MONTGOMERY COUNTY PLANNING DEPARTMENT
THE MARYLAND-NATIONAL CAPITAL PARK AND PLANNING COMMISSION

MEMORANDUM

SUBJECT: Observation Drive Extended Phase I Transportation Facility Planning Study -
Project Prospectus Recommendations

SUBJECT: DEPARTMENT OF PARKS REVIEW OF OBSERVATION DRIVE
EXTENDED: PHASE 1 FACILITY PLANNING STUDY

FIGURE: **8E**

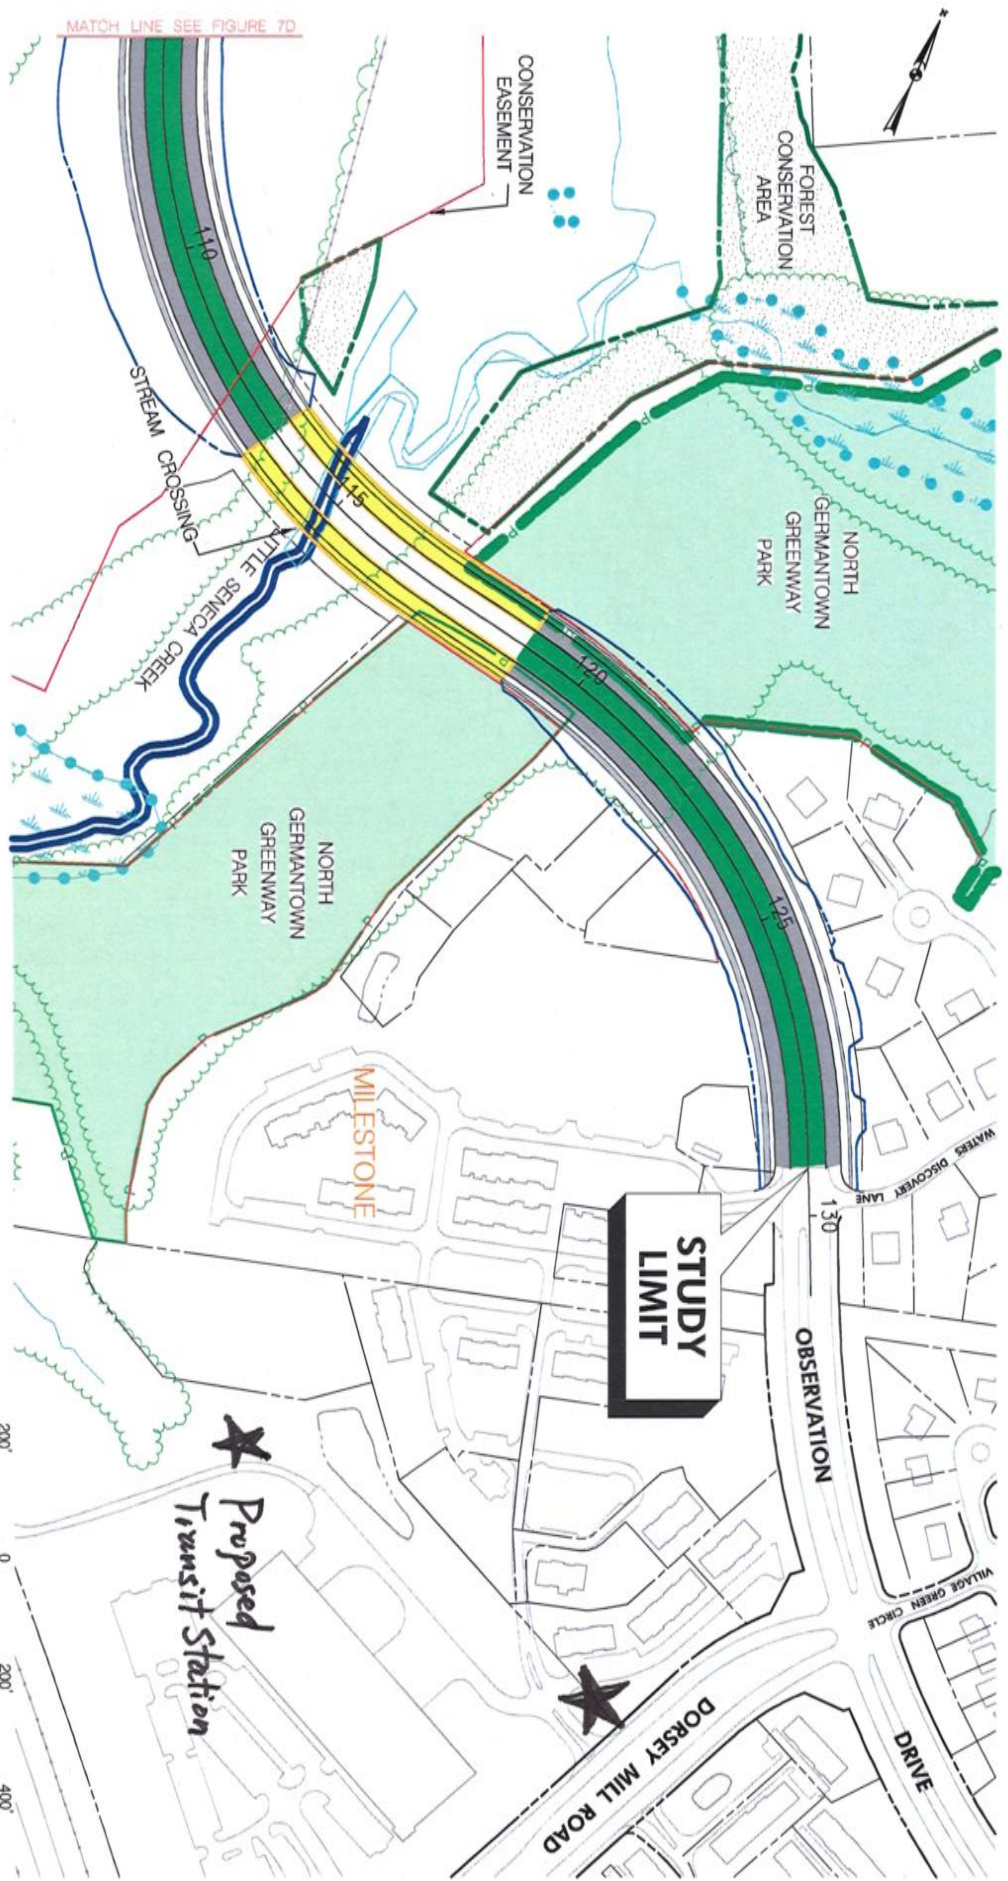
1. The Observation Drive Extended Transportation Facility Planning Study should proceed to Phase II of the Facility Planning process as recommended in the September 2008 Project Prospectus to develop a detailed design for Alternative 4, Master Plan Alignment Adjusted, after including the required horizontal and vertical geometric criteria for light rail transit (LRT) and addressing the comments of the Maryland Transit Administration (MTA).
2. Per the Project Prospectus recommendation, the design for Observation Drive Extended should be a four-lane closed section roadway as recommended in the Germantown and Clarksburg Master Plans.

- b. Consider narrowing the median width to approximately 36 feet outside station areas to reduce impacts in environmentally sensitive areas where station platforms and left turn lanes are not needed.

- f. Include spirals in the roadway horizontal geometry so that LRT can be accommodated without variations in the median offset.
6. During the Phase II Facility Planning study, mitigation strategies for impacted Conservation Easement areas must be identified.

Third, it appears that a 50 mph *roadway* design speed was used for this study rather than a 50 mph rail design speed, which would have required longer, flatter curves both vertically and horizontally, and created more impacts on adjacent properties and environmental resources. It appears that the current design would accommodate only a 27 mph operating speed for LRT along the curves in the Little Seneca Creek Stream Valley.

Given that this project has three stream crossings and impacts wetlands, one Conservation Easement, and North Germantown Greenway Park, strong consideration should be given to using a 36-foot-wide median outside station areas. The Army Corps of Engineers required a similar reduction in the median width of the Montrose Parkway West project as a condition of their permit for the stream crossing on that project. Master planned right-of-way has been established for Observation Drive as it crosses North Germantown Greenway Park. **The effects of a potentially narrower median but wider sidewalks recommended by staff on the bridge over Little Seneca Creek should be examined in Phase II.** We have an MOU with MCDOT that addresses how any park impacts of master planned roadways should be addressed. The project also impacts a 1.6-acre Conservation Easement on the Moyer and Sons property. This Conservation Easement predates both the 1991 Forest Conservation Law and the establishment of the Observation Drive alignment in the 1994 Clarksburg Master Plan. During Phase II mitigation strategies for impacted Conservation Easement areas must be identified.

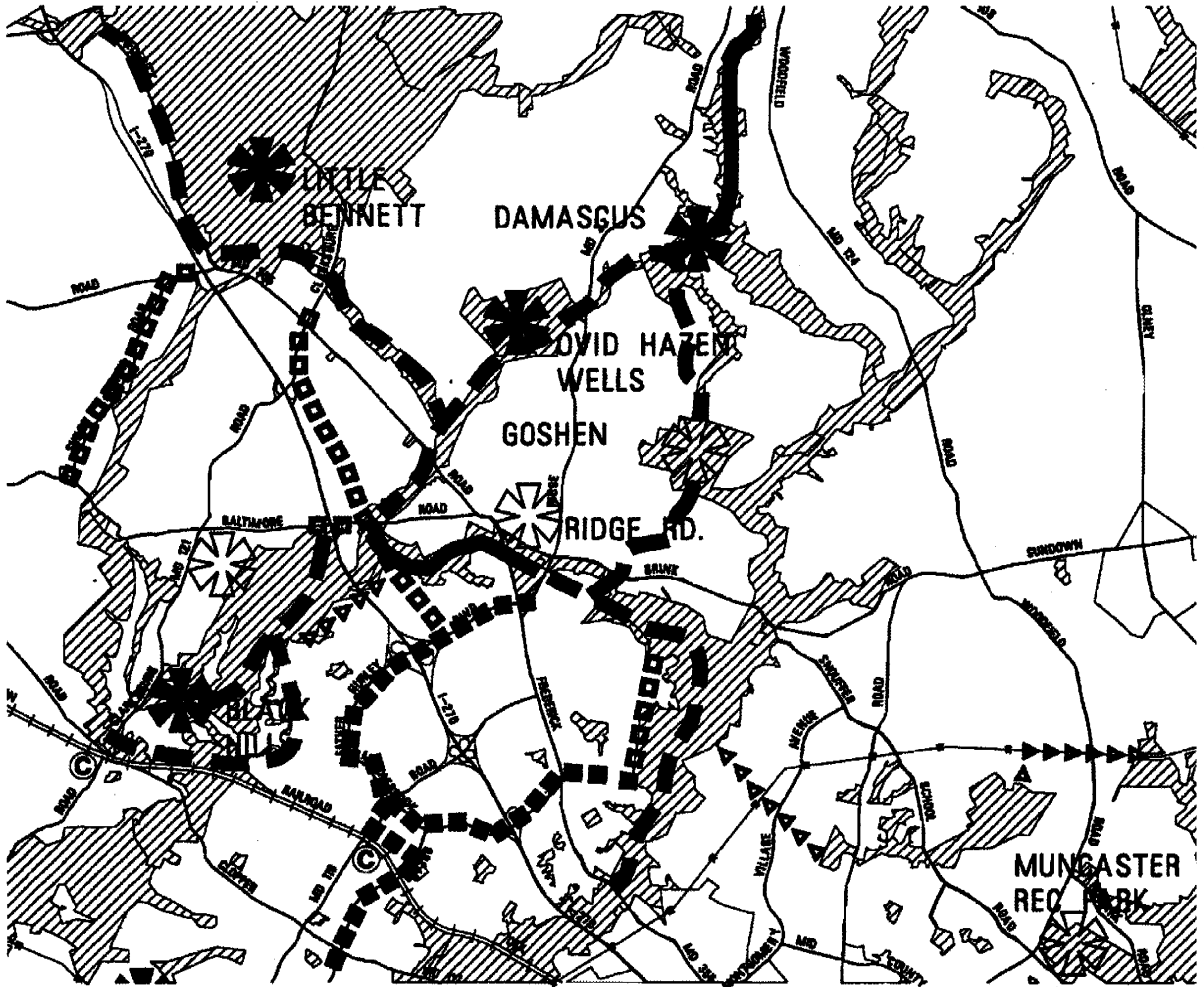
Instead the Phase 1 Facility Plan directs pedestrians and cyclists to the west side of Observation Drive, to an area zoned for industrial uses that will feature curb cuts and driveway aprons. It will also require users to cross Observation Drive twice. We are not disagreeing that a bike trail should be on the west side; we have been recommending for 3 years that a bike trail also be provided on the east side for this critical less than mile stretch.

In closing, there is no discussion or rationale in the Phase 1 Facility Plan for placing a sidewalk rather than a bike trail on the east side in this one section of the project. For all the reasons stated, Department of Parks feels that in the public's best interest a bike trail on the east side should be part of the Phase 2 Facility Plan for Observation Drive Extended.
